PLANNING BOARD

Tuesday, August 13, 2024 at 4:30 PM
Room 24 (Ground Level of City Hall) and
Zoom

**STAFF MEMORANDUM
HISTORIC PRESERVATION PROGRAM
PLANNING AND URBAN DEVELOPMENT**

SHEET: C-4.0

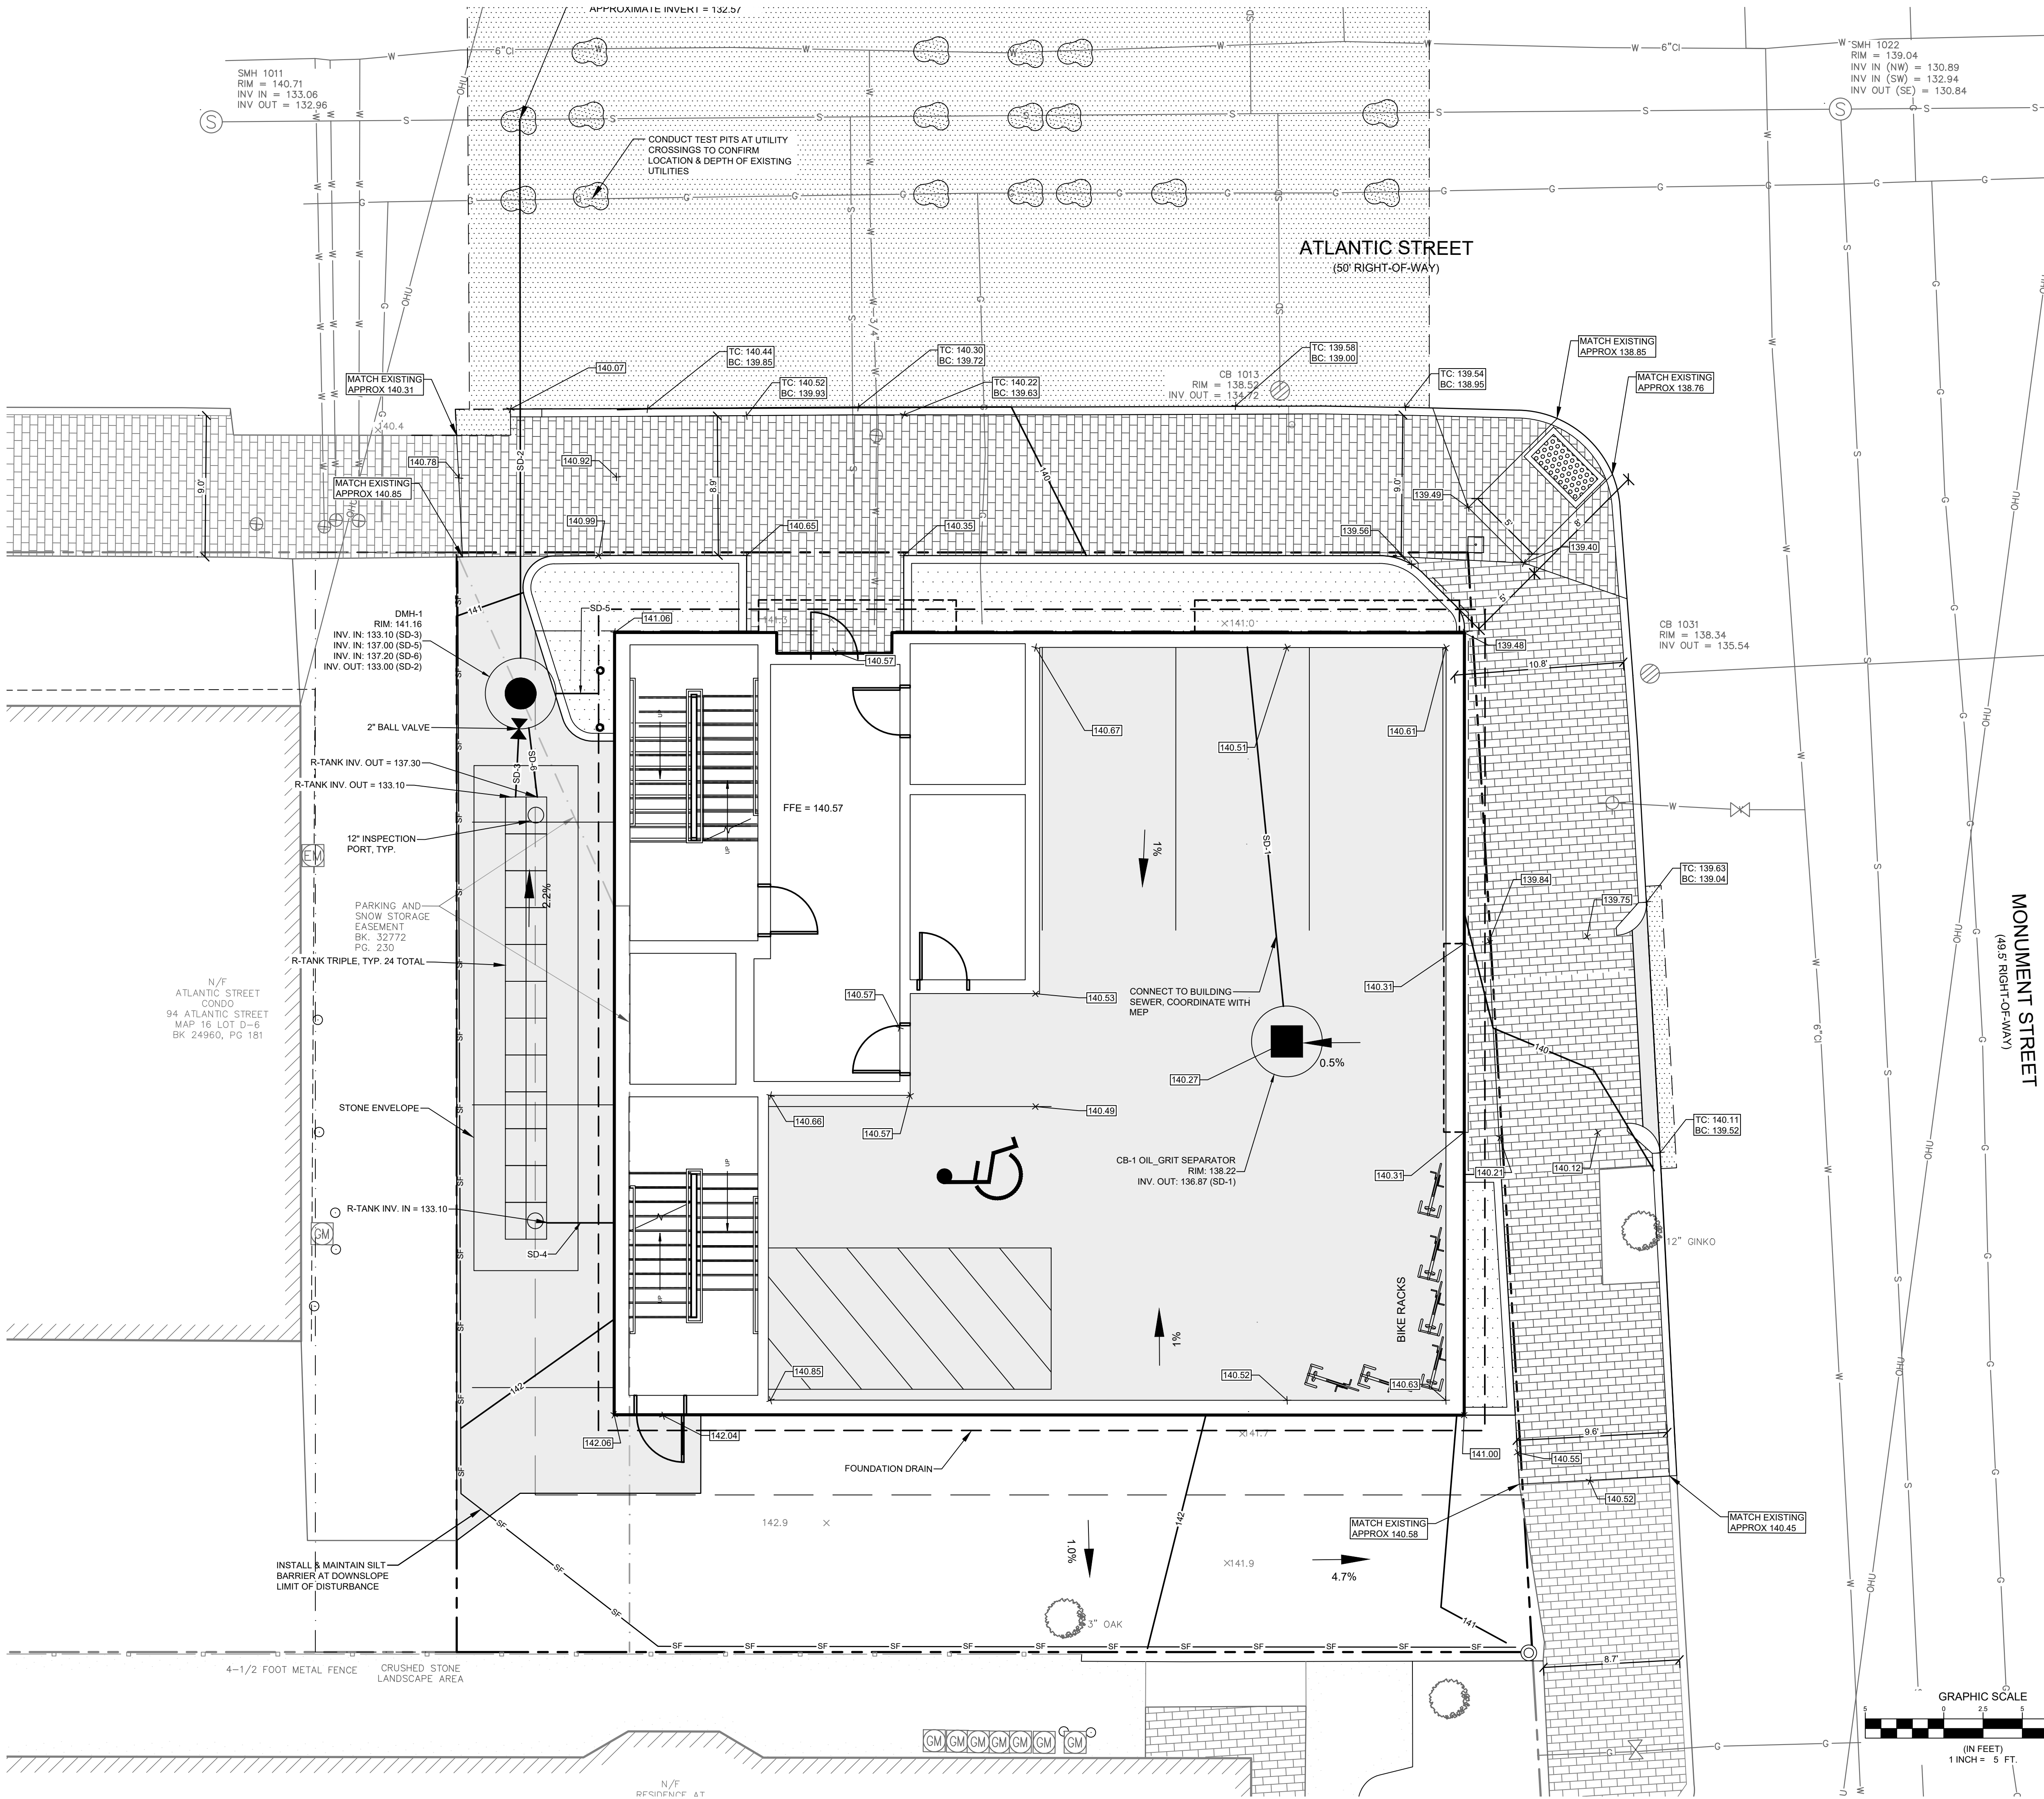
Comment: Update C-4.0 - Callout protection of Monument

Comment: C-4.0 - ADA ramp appears to be non-compliant per the Technical Manual; replace ramp and sidewalk

Response: The driveway width has been dimensioned on sheet C-4.0.,

Response: Monument protection callout has been added to sheet C-4.0.
